WATER DEPARTMENT
CITY OF ROANOKE, VA.
PROFILE
NEW PETERS CREEK BRIDGE
PETERS CREEK & MELROSE AVE.
PROPOSED 12" MAIN CROSSING
DRAWN BY E.L.A. — MARCH, 13, 1950

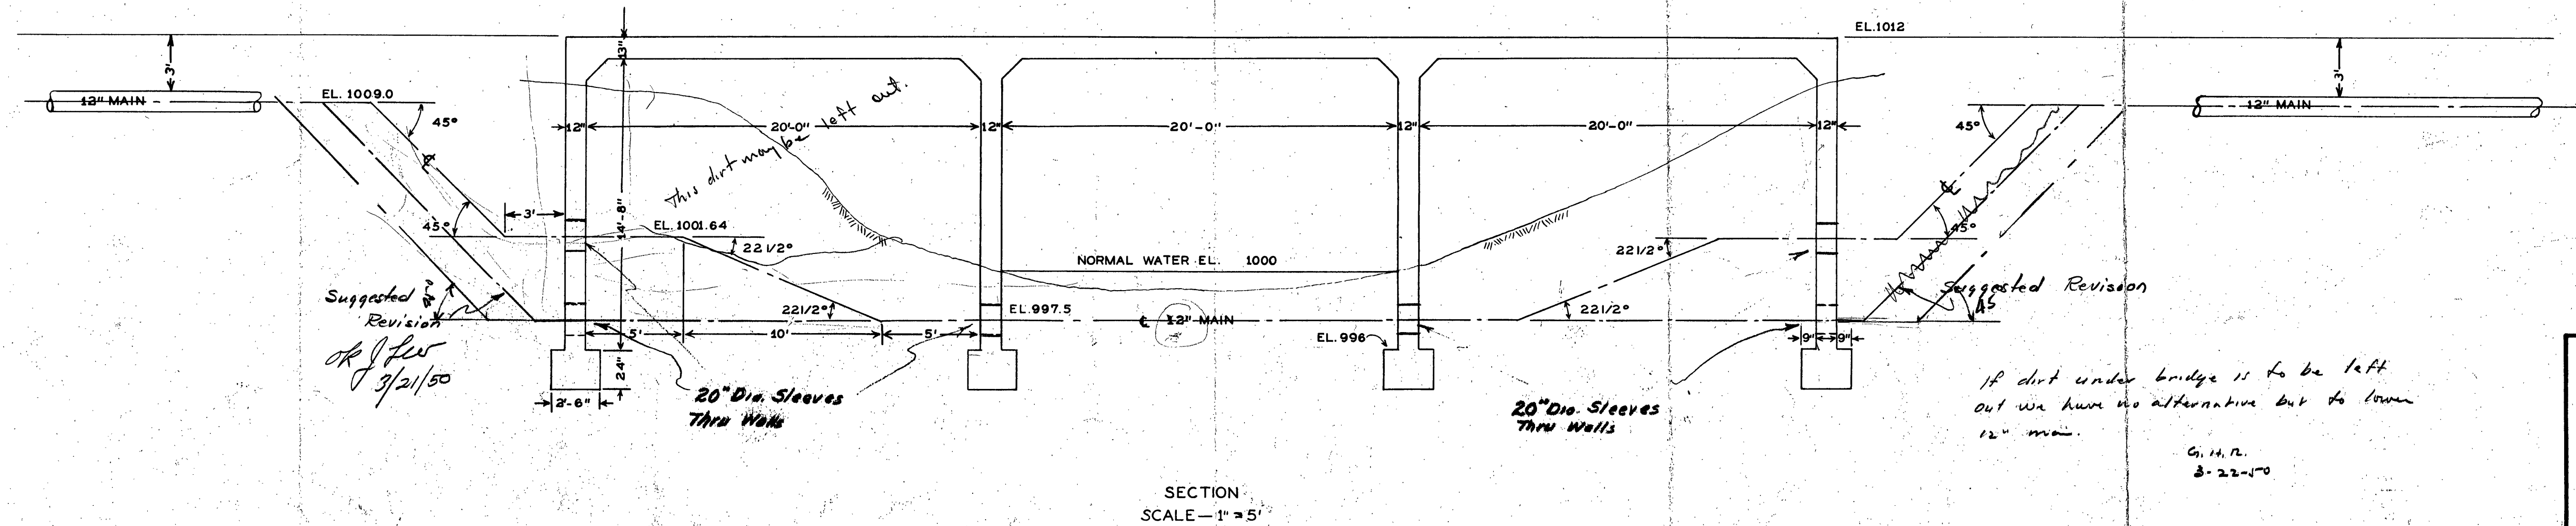
If dirt under bridge is to be left out we have no alternative but to lower 12" main.
